STATE OF MARYLAND WELL COMPLETION REPORT

RE: Grout Correction  
Twelve Hills - Lot 28  
Well Tag Number: HO-88-0540  
13058 Twelve Hills Road

RE: File Number:F-04-91  
Title: Twelve Hills, Lots 51 &52

Notes/Well  
Stake location

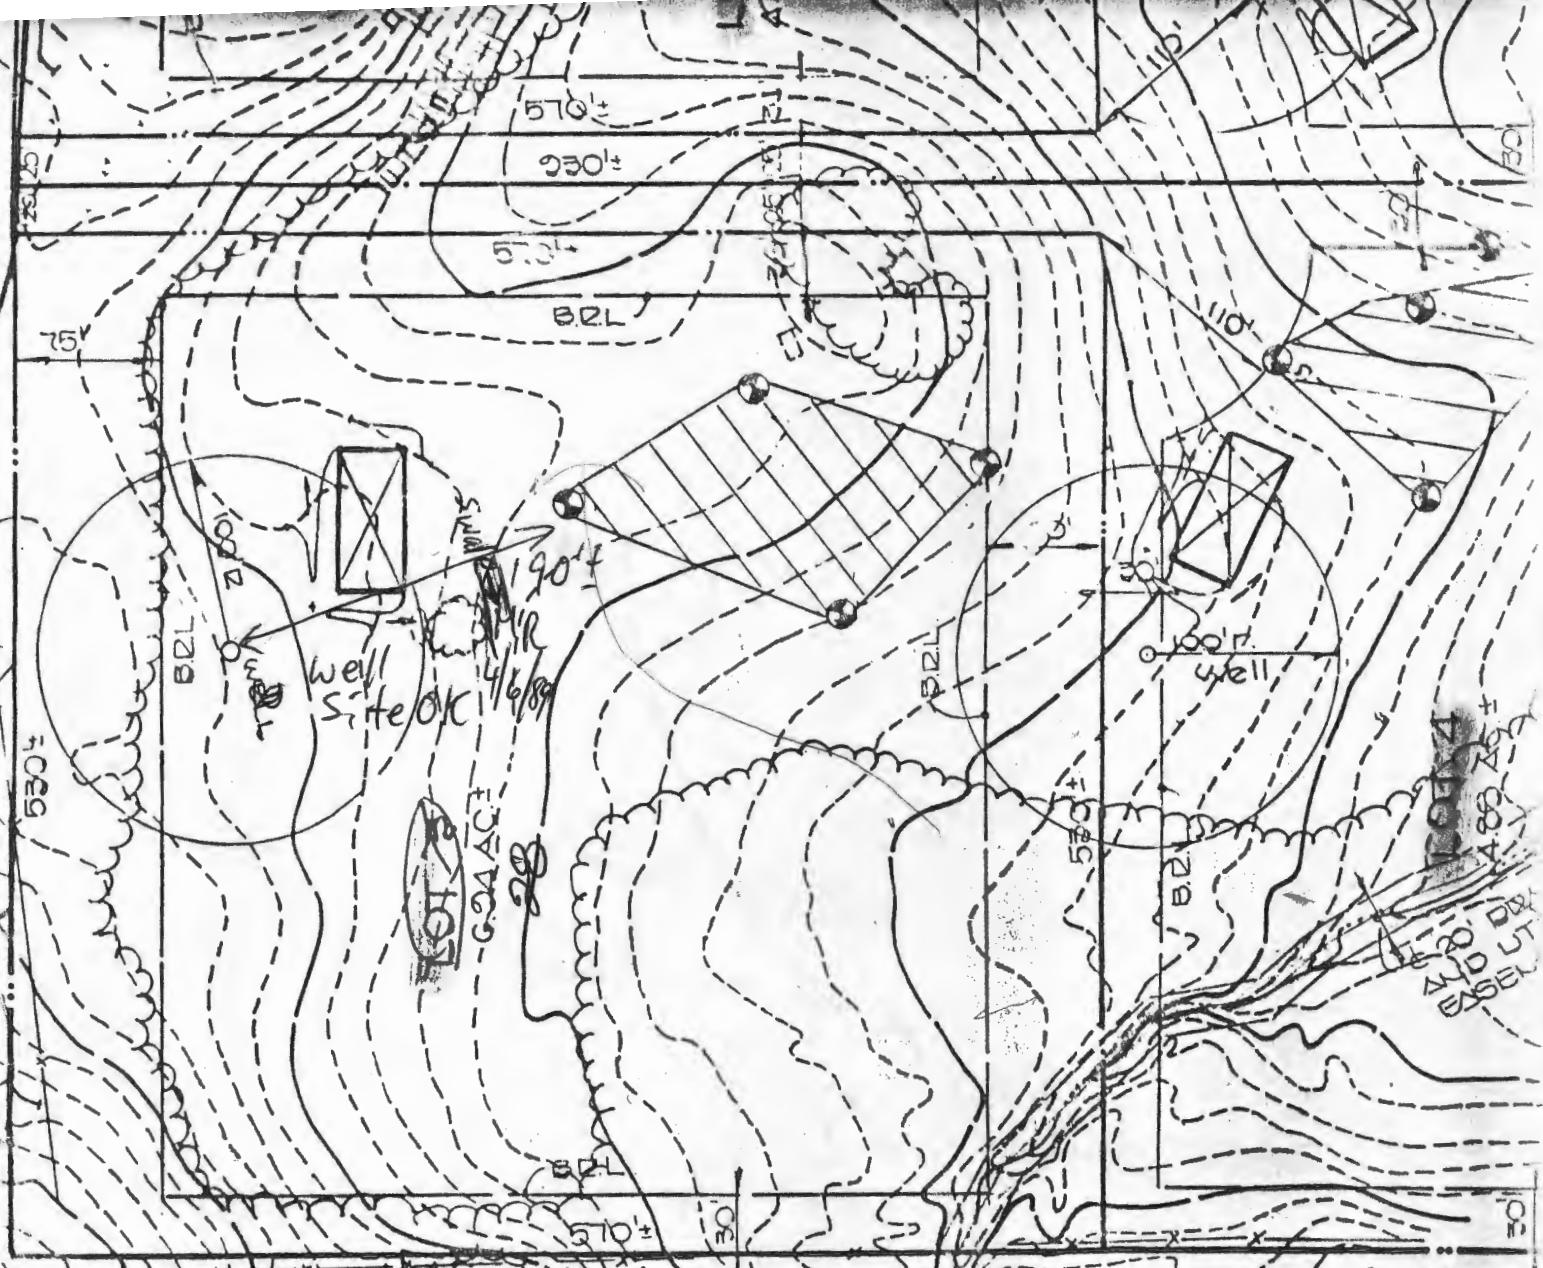
OK (S)

8/3/04

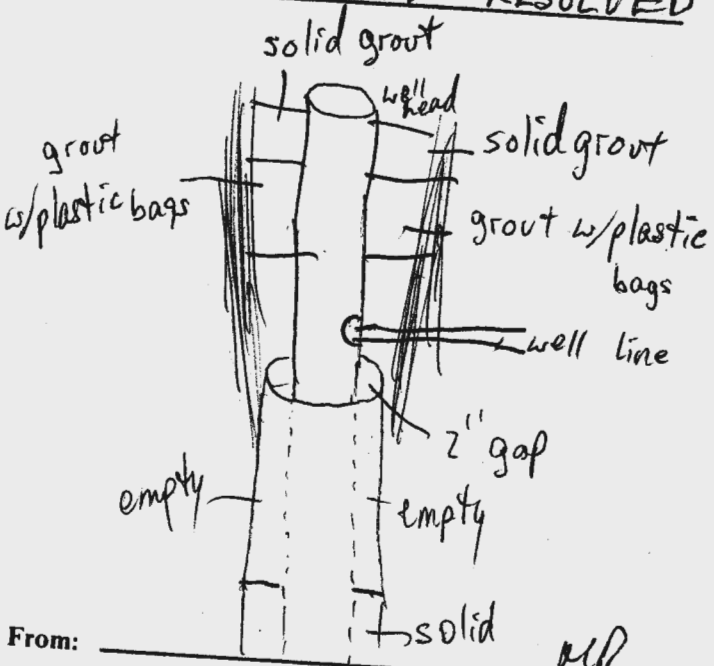
9/9/04 - Allan Compton of Foyles  
called. Said 1<sup>st</sup> well location is  
caving as they drill. OK to move  
to lower side of well box (SO)

10/6/04 - Spoke to Allan Compton in the  
field about another well box. Said 2<sup>nd</sup>  
well they drilled caved in also. (SO)

10/14/04 - Resubmission OK, Called Foyles  
OK to drill (SO)
